Research Greenhouse
Project No. FM090158S/981530
Addendum No. 4

ADDENDUM NUMBER 4

April 10, 2009

SK-1 LIMITS OF CONSTRUCTION FENCING, Dated 04/09/2009, attached.

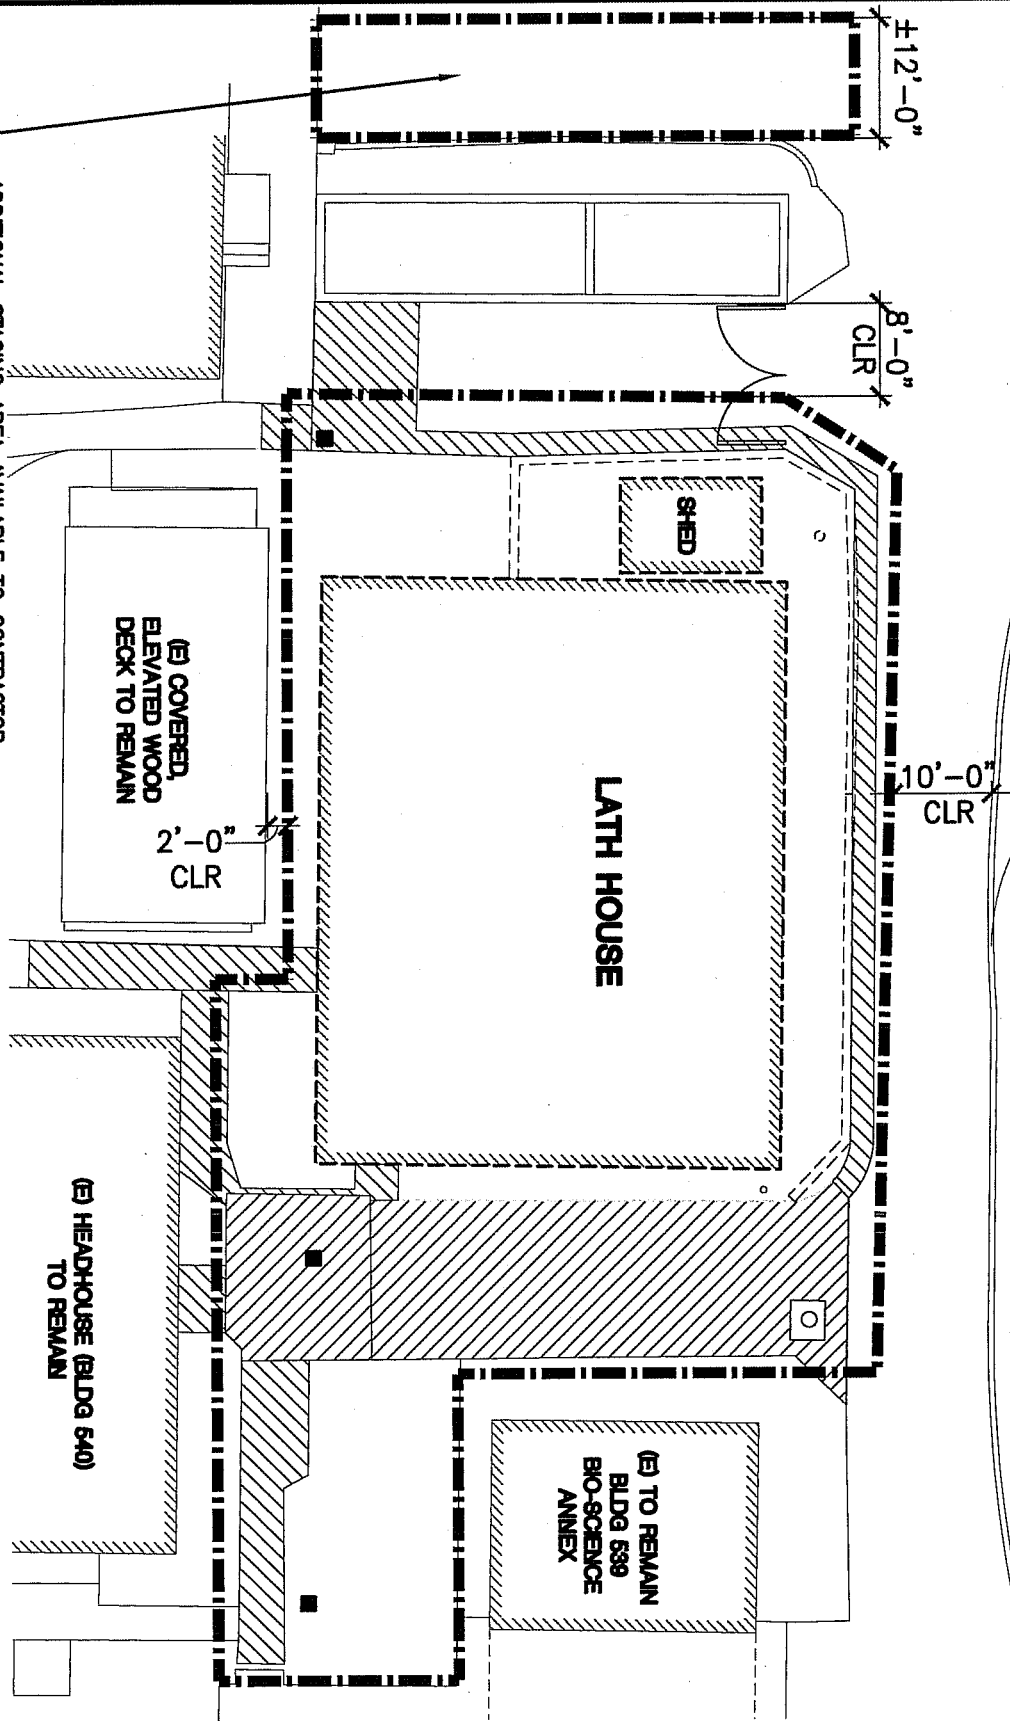
- A. Fencing: Before beginning demolition and site clearing, erect temporary construction fence around entire perimeter of work site per the attached sketch SK-1, and maintain construction fence in good condition until removal is approved by University Representative.”

SHEET TITLE
SITE PLAN ELECTRICAL

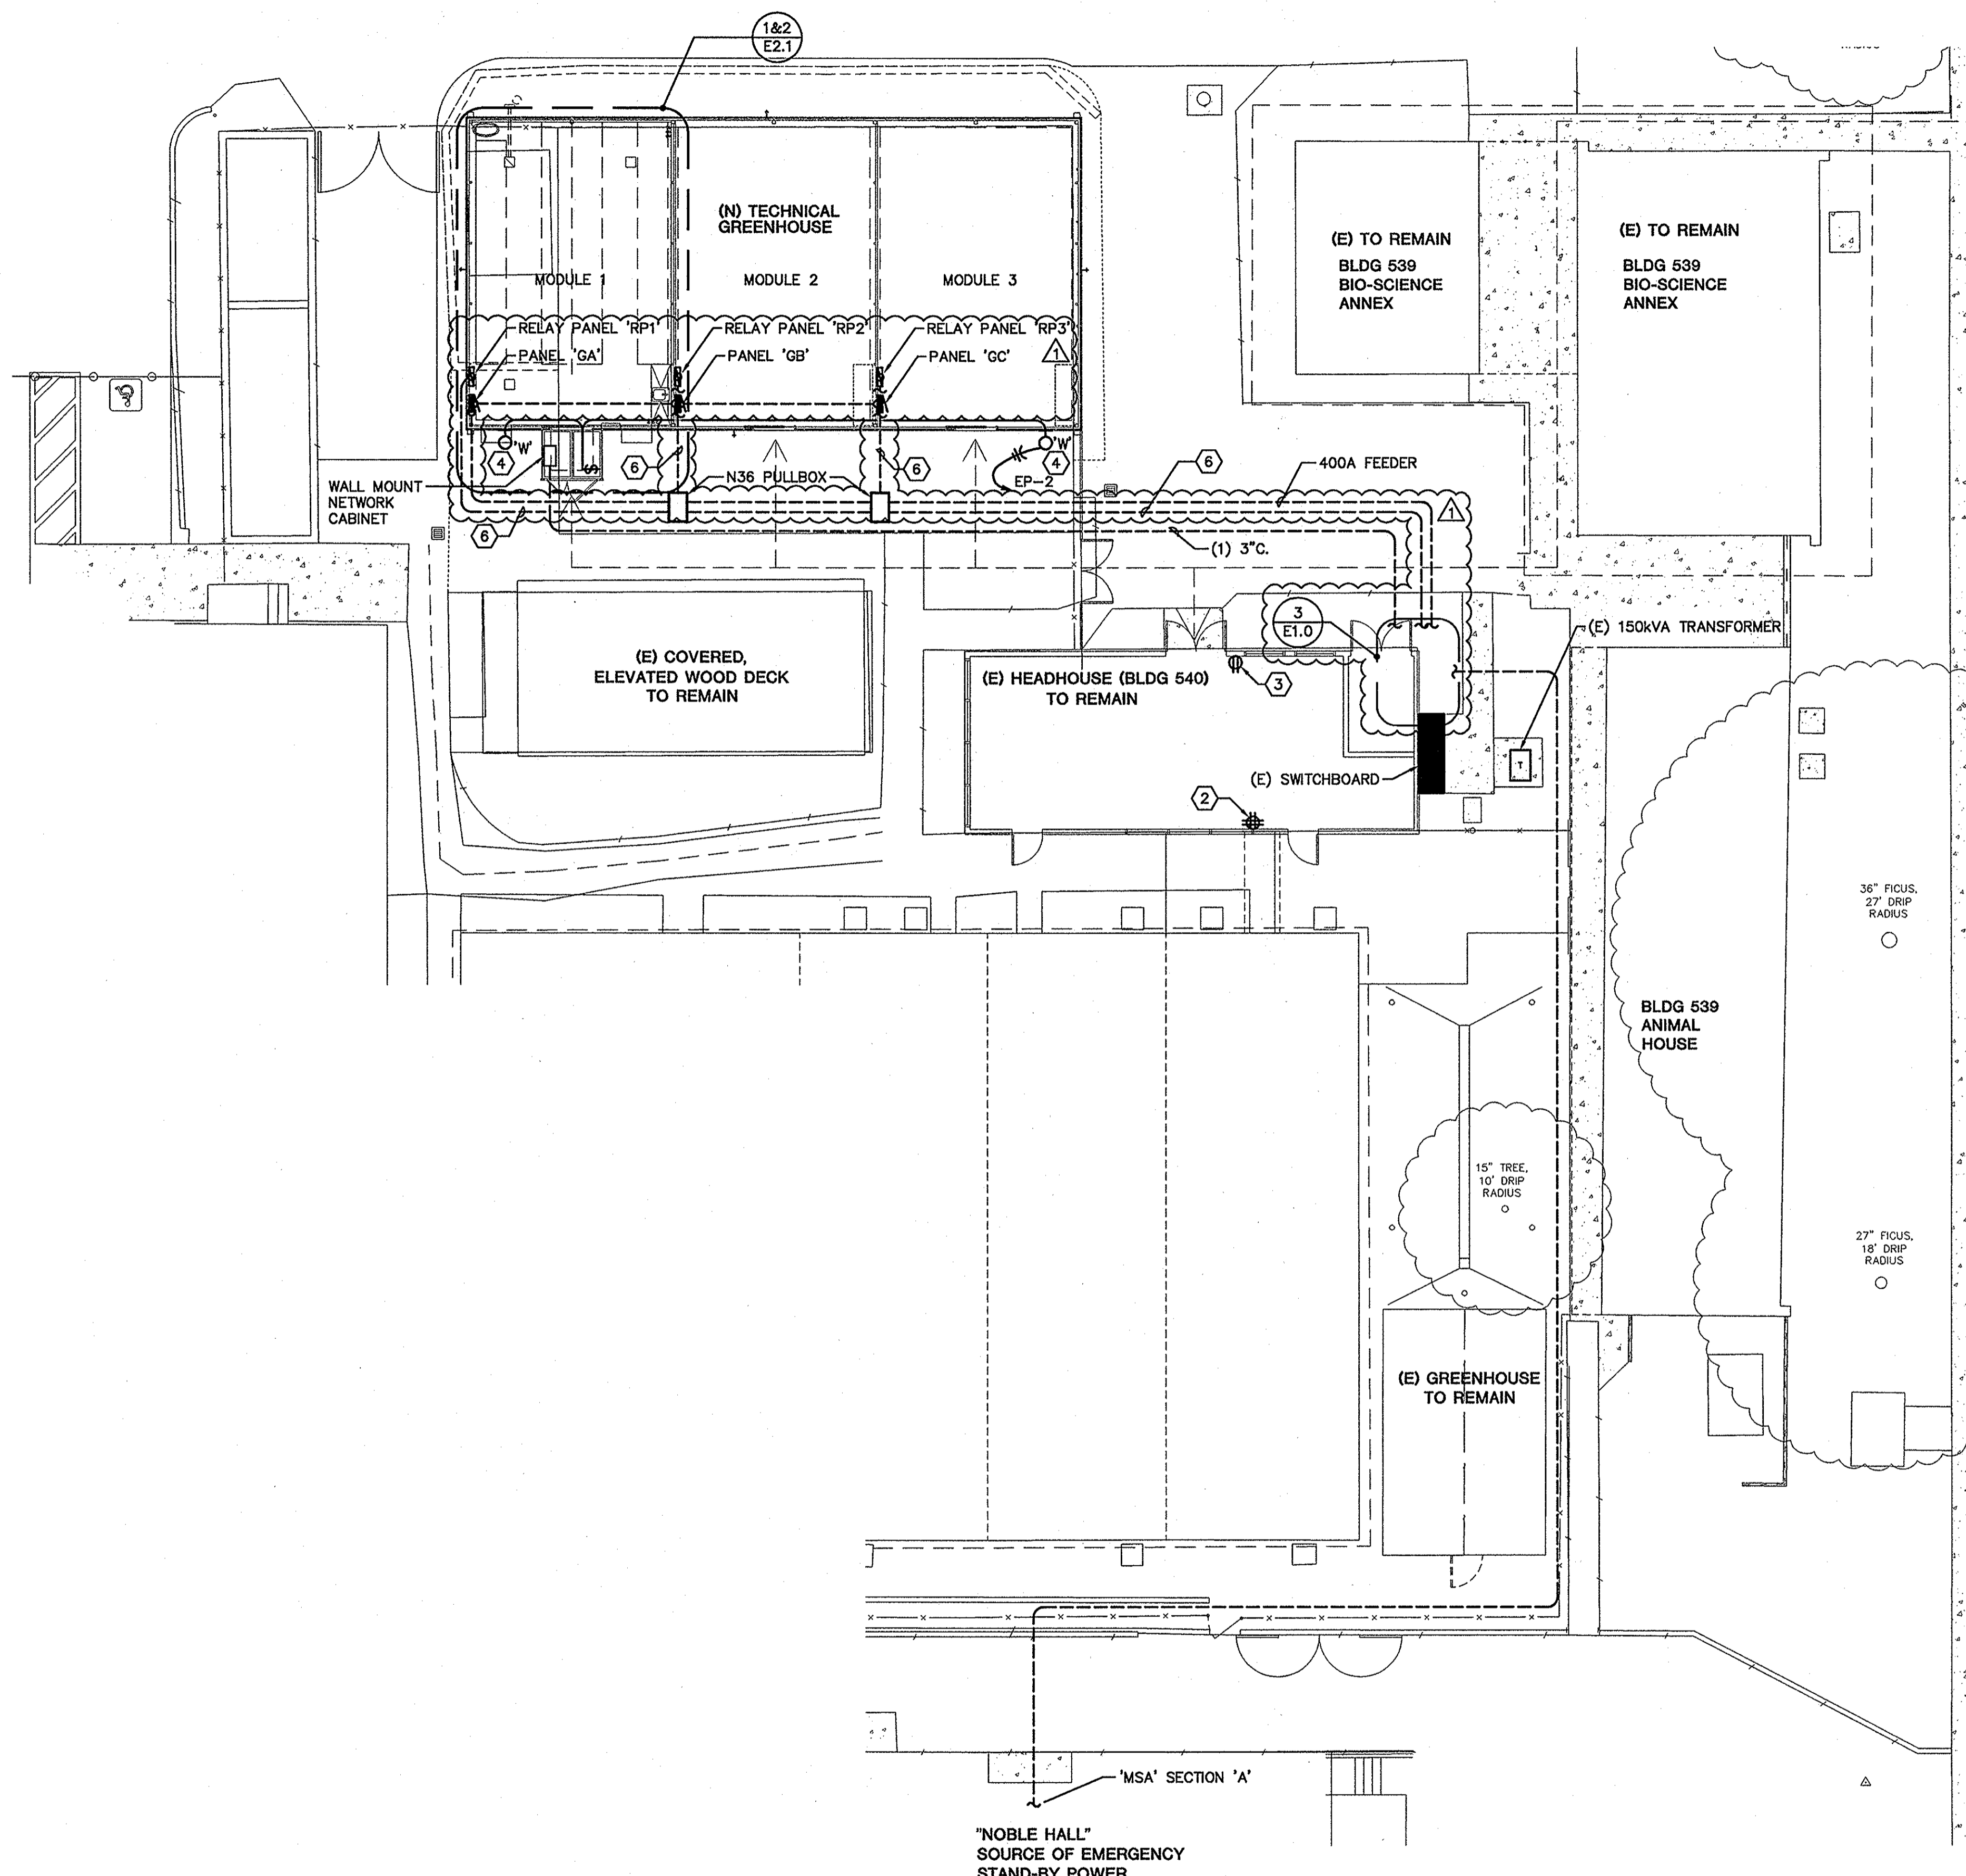
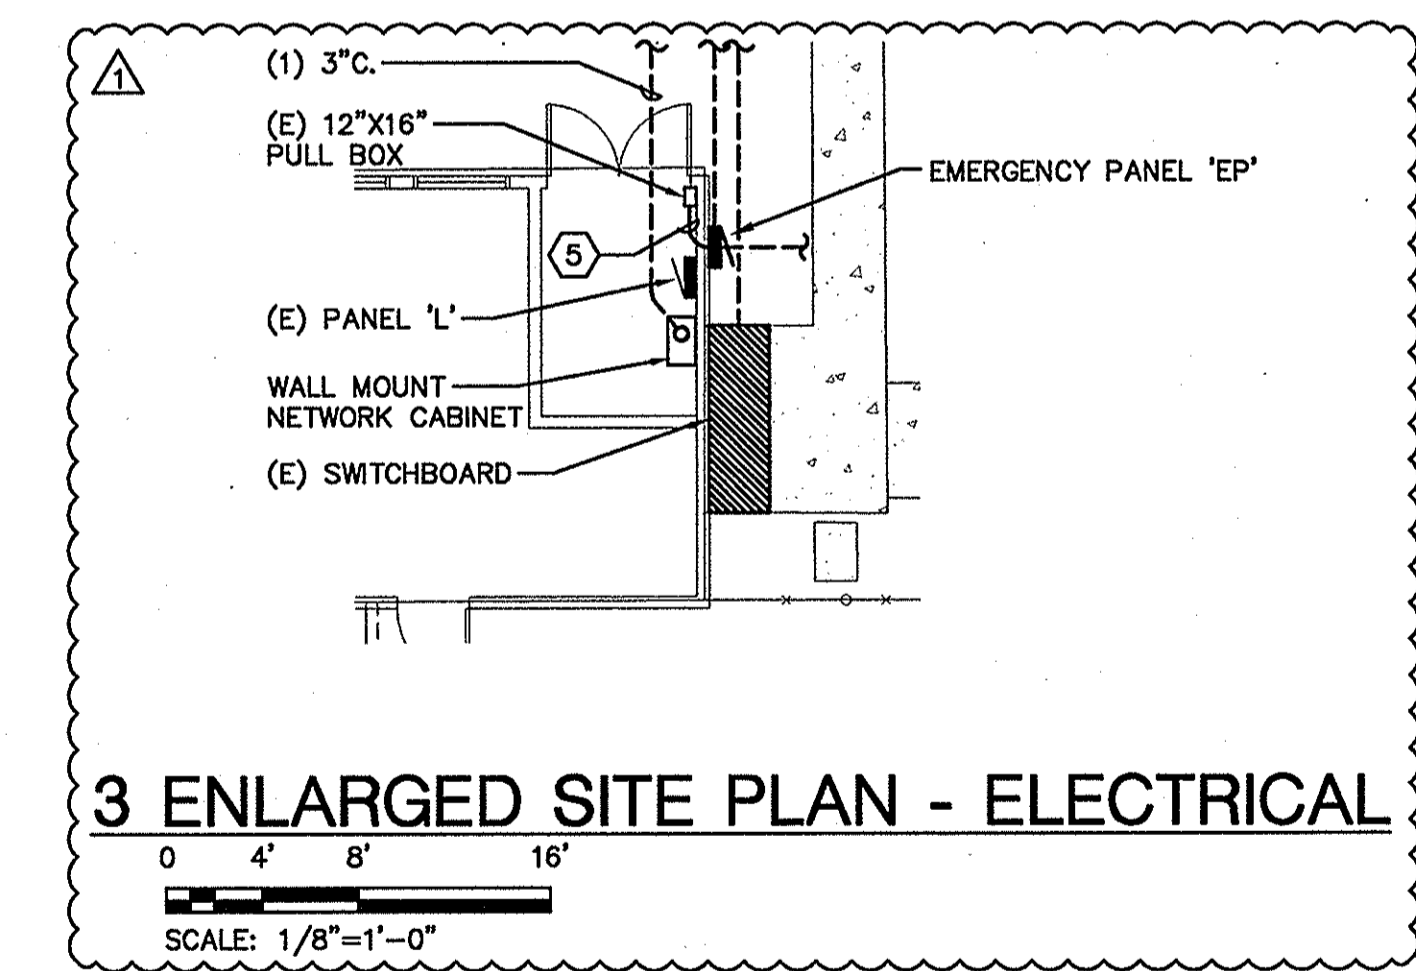
11. Sheet E1.0, SITE PLAN ELECTRICAL. (This note is in addition to the drawing revisions reflected in the revised Drawing E1.0, dated 04/10/2009.): **Add** the following note in its entirety:

"At Contractor's Option, University will allow an alternate route for the new conduit/conductor run from the MSA in Noble Hall to the new emergency panel EP. Starting from the MSA in Noble Hall, once conduit has exited Noble Hall, it may proceed west, above grade, on the surface of the concrete wall north of Noble Hall, parallel to other existing conduits. Then the conduit may continue north on the exterior wall surface of Pharmacology Building 569 clear to the NE corner of Building 569. Then route underground from there to emergency panel EP at east end of Headhouse. All above grade conduit shall be rigid metal and not EMT (even if existing conduits are EMT). Submit exact details of this alternate routing for final University approval."
